The Fire Safety & Building Code of Australia (2019) assessment report (dated 7th December 2022) for SP47991 at 41 Rocklands Road, Wollstonecraft, was prepared in response to a Fire Order from North Sydney Council in August 2022. The report is based on on-site audit inspections conducted by Building Code Professionals (BCP), Grant McGrath and is stated as being in compliance with the Building Code of Australia (2019), which includes NSW variations.

On page 4 of the report, reference is made to section C1.2 of BCA (2019), which pertains to RIS (Rise in Storeys) and the building's Effective Height. These parameters are crucial in assessing whether the building meets the BCA performance requirements. The BCP report states that the building has a RIS of eleven (11) and an effective height of greater than 25.0 metres (i.e., 27.7 metres).

Guide

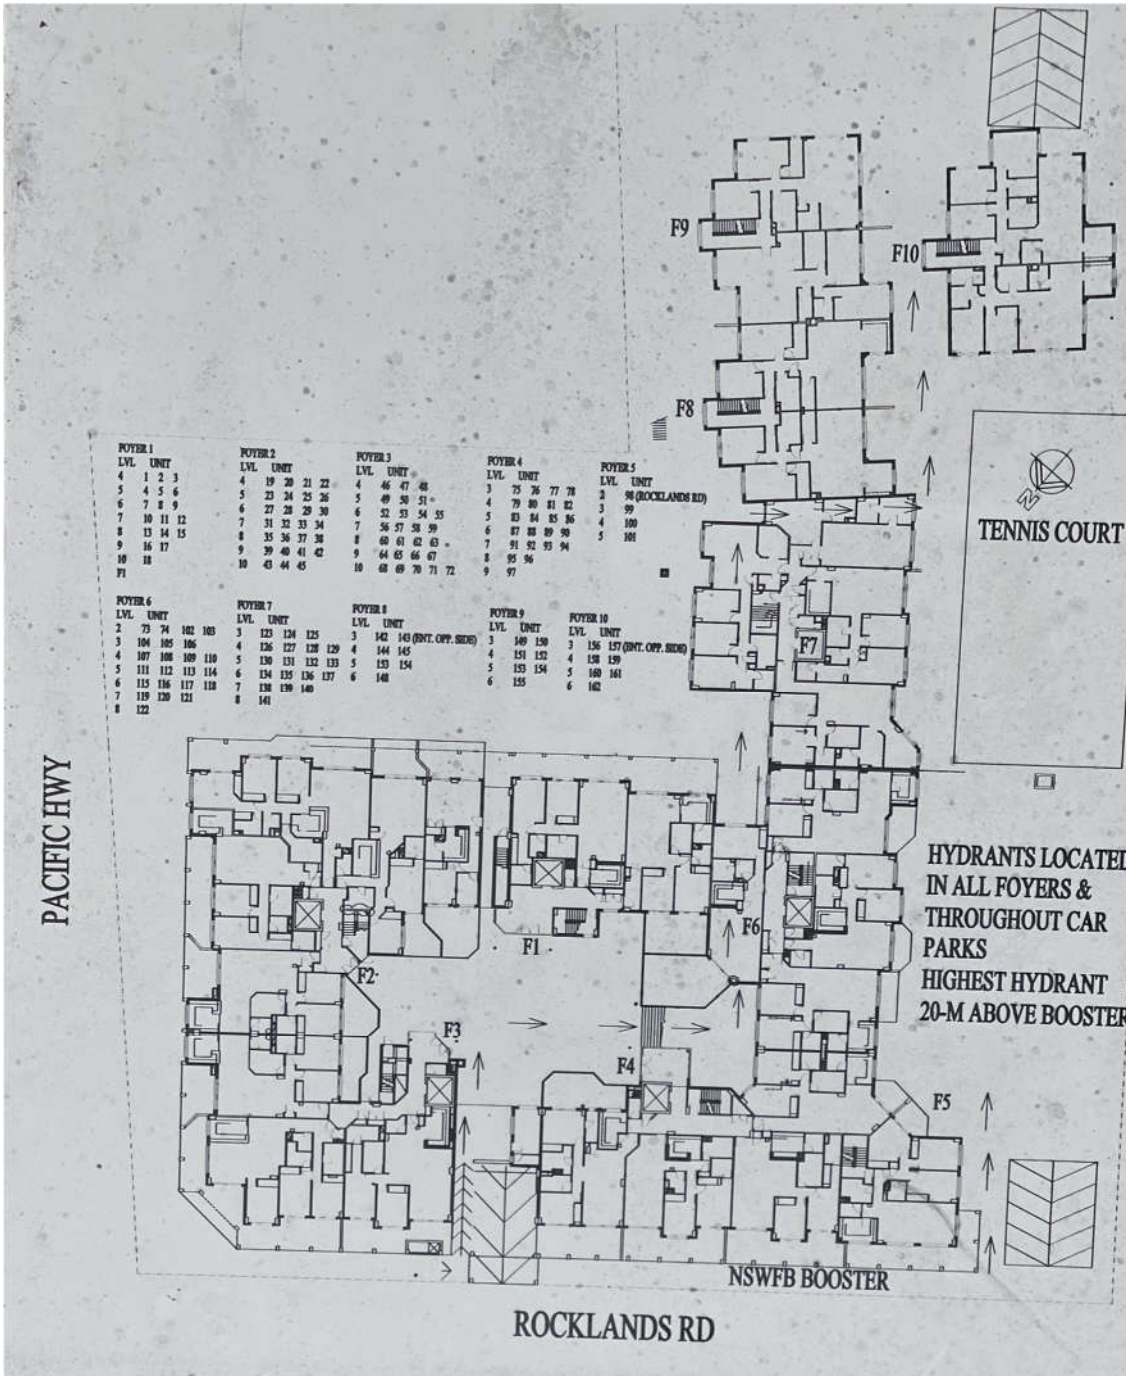
Under C1.2(a), the rise in storeys is the sum of the greatest number of storeys at any part of the external walls of a building above ground level and any storeys within the roof space. The reason for the inclusion of any storey within the roof space is that the storey may not have any external walls such as occur with a hip roof.

C1.2(a)(i) and (ii) distinguish between the situation where the part of the external walls is within the allotment (in which case it is calculated above finished ground level—C1.2(a)(i)), or on the allotment boundary (in which case it is calculated above natural ground level at that point—C1.2(a)(ii)).
